SUBJECT: FORWARDING A PROPOSED REVISION TO CERTIFICATE OF  
COMPLIANCE NO. 1004

**Proposed Revision to CoC No. 1004**

Certificate No. 1004 -  
Amendment 2

**CERTIFICATE OF COMPLIANCE NO. 1004**

Figure 1.1

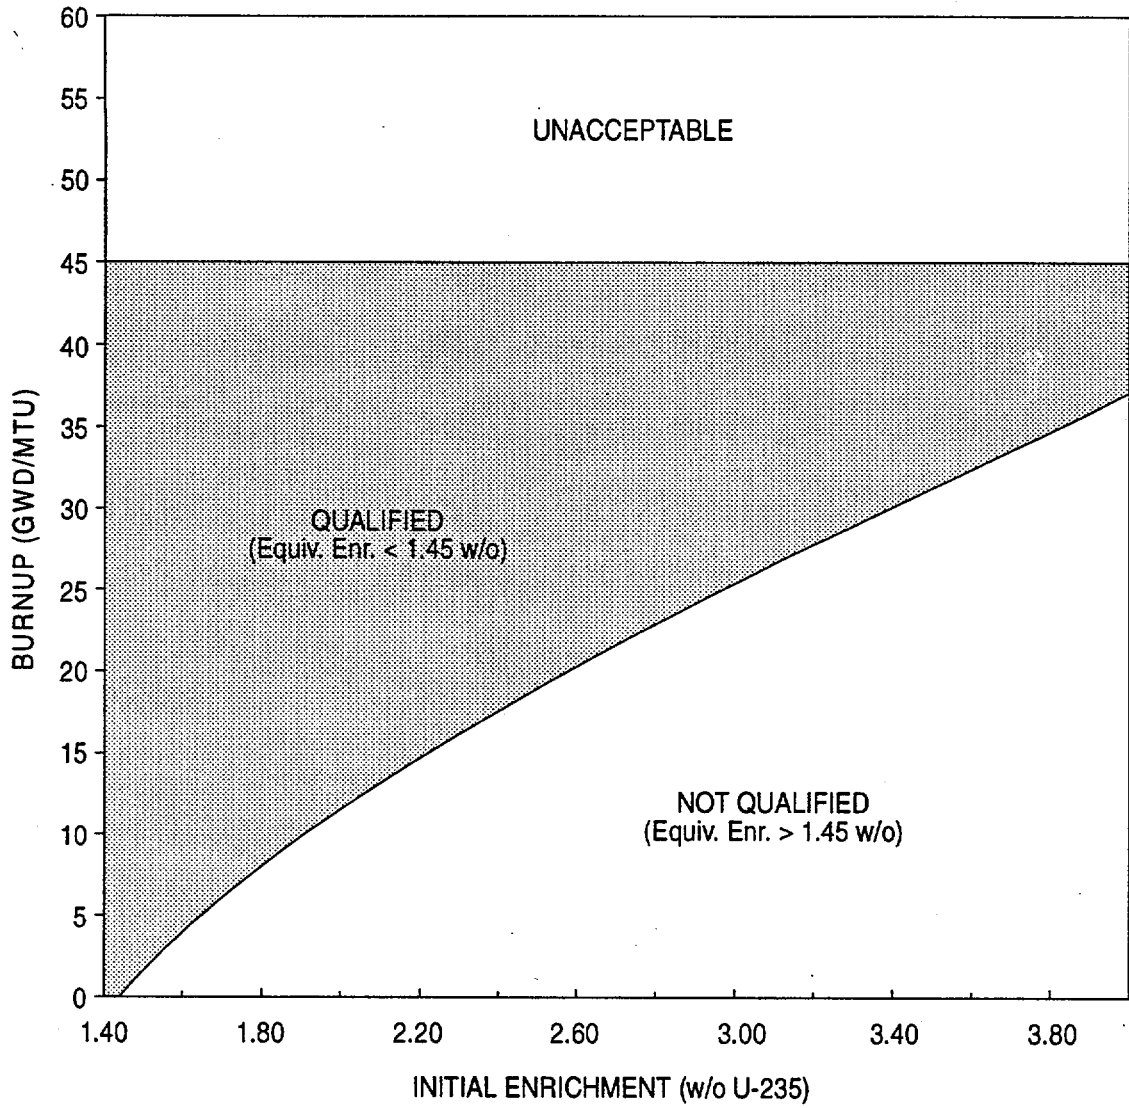
Alternate Nuclear Parameters Initial Enrichment Burnup Decay Heat (Fuel + BPRAs) Neutron Fuel Source  Gamma (Fuel +BPRAs) Source	≤ 4.0 wt. % U-235 ≤ 40,000 MWd/MTU and Per Figure 1.1 ≤ 1.0 kW per assembly ≤ 2.23 x 10 <sup>8</sup> n/sec per assy with spectrum bounded by that in Chapter 7 of SAR ≤ 7.45 x 10 <sup>15</sup> g/sec per assy with spectrum bounded by that in Chapter 7 of SAR

Burnup (GWd/ MTU)	Initial Enrichment (w/o U-235)																																							
	2.0	2.1	2.2	2.3	2.4	2.5	2.6	2.7	2.8	2.9	3.0	3.1	3.2	3.3	3.4	3.5	3.6	3.7	3.8	3.9	4.0																			
10	Not Acceptable per Figure 1.1																																							
15																				5	5																			
20																				5	5	5	5	5																
25																					5	5	5	5	5	5	5	5												
28																							5	5	5	5	5	5	5	5										
30																									5	5	5	5	5	5	5	5								
32																										5	5	5	5	5	5	5	5	5						
34																											6	5	5	5	5	5	5	5	5	5				
36																												6	6	6	6	5	5	5	5	5	5	5		
38																														7	6	6	6	6	6	6	6	5	5	5
40																																8	8	8	7	6	6	6	6	6
41																																	9	9	9	8	8	8	8	8
42																																		10	9	9	9	9	9	8
43																																			10	10	10	10	9	9
